INITIAL FIRE SAFETY INSPECTION REPORT

DK Global Fashion Wear Ltd.

RSC ID: 24677

Fire Safety Inspection Report

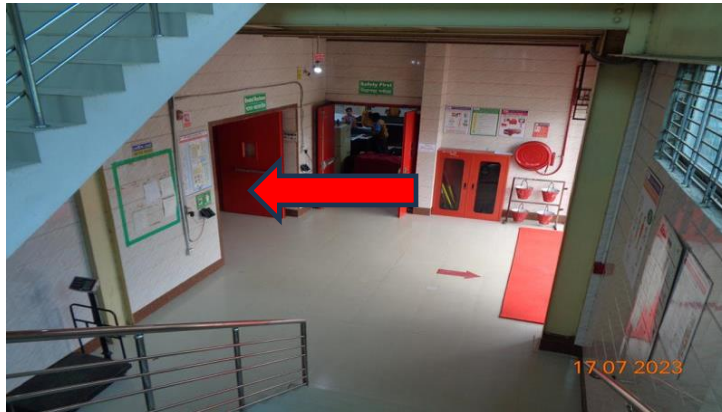
F-3	Fire Rated Construction	Storage rooms at ground floor discharges directly into the exit stair discharge.	Openings from exit enclosure to storage room, generator and hazard spaces shall be provided with a vestibule with fire rated construction and openings. Provide a 1 hr. fire rated door on the exit stair side and a 1-hr. fire rated door on the Store room side. Ensure that the fire rating of the vestibule construction matches that of the exit stair enclosure.	Within 3 Months
-----	-------------------------	--	--	-----------------

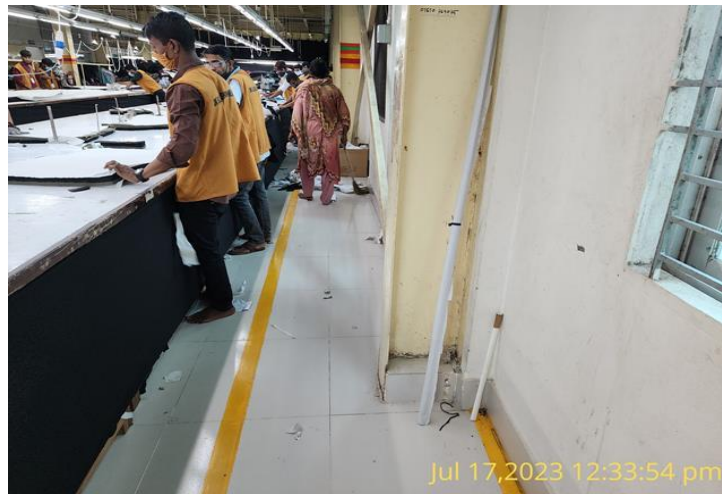
F-12	Means of Egress	Adequate & unobstructed aisles were not provided. Location: Ground floor	Provide minimum and clear aisle width of 36-in where applicable and required.	Within 1 Month
------	-----------------	---	---	----------------

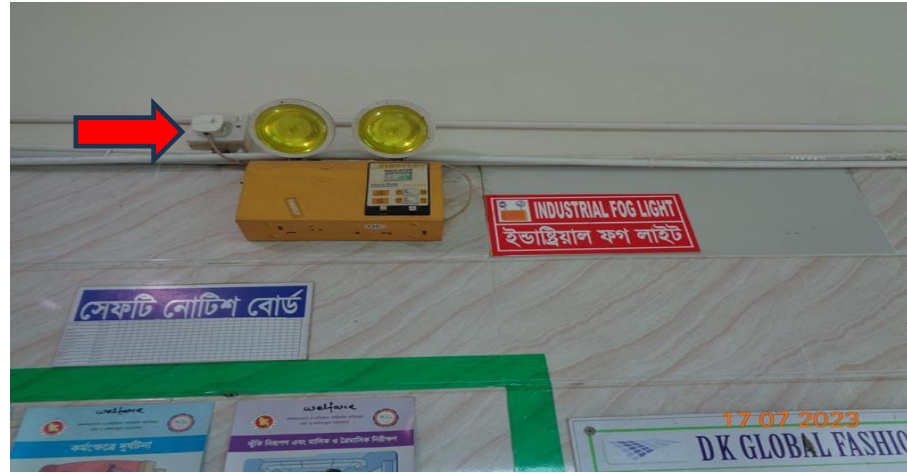
F-15	ITM of Emergency light and Exit Sign	Inspection, testing, and maintenance for the exit sign and emergency lighting system was not in accordance with The RSC Technical standard.	Inspect, test and maintain the exit sign and emergency lighting system in the accordance with The RSC Technical standard. Keep written records on-site.	Within 1 Month
F-16	Egress Lighting	Manual On/Off Switch is provided at emergency lighting.	Remove manual on/off switches from emergency lighting / exit signage units to prevent them from being switched off.	Within 1 Month
